Board fragment showing addition of smoothing capacitor.  
PCB 98002 ISSUE 3.

#### Reason for modification:

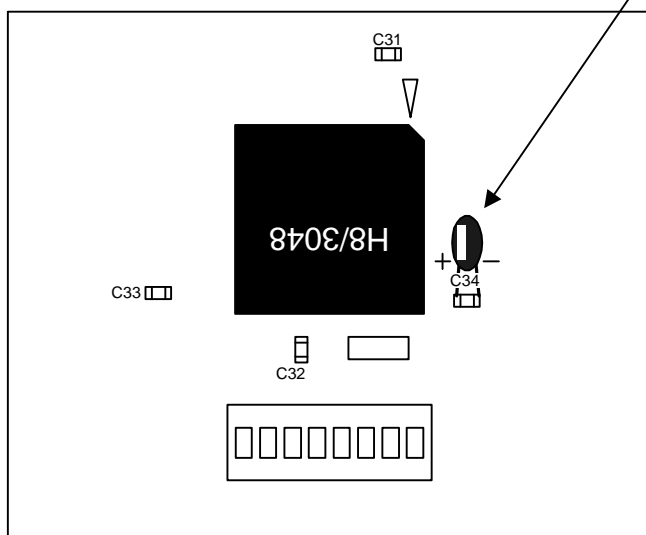
System noise can cause pan/tilt hunting during goto preset operation as preset reference voltage can fluctuate.

The additional capacitor suppresses this noise.

Value: between 1 & 10uF 16V TANTALUM BEAD CAPACITOR

A suitable part is supplied by RS Components with part number: 180-1595
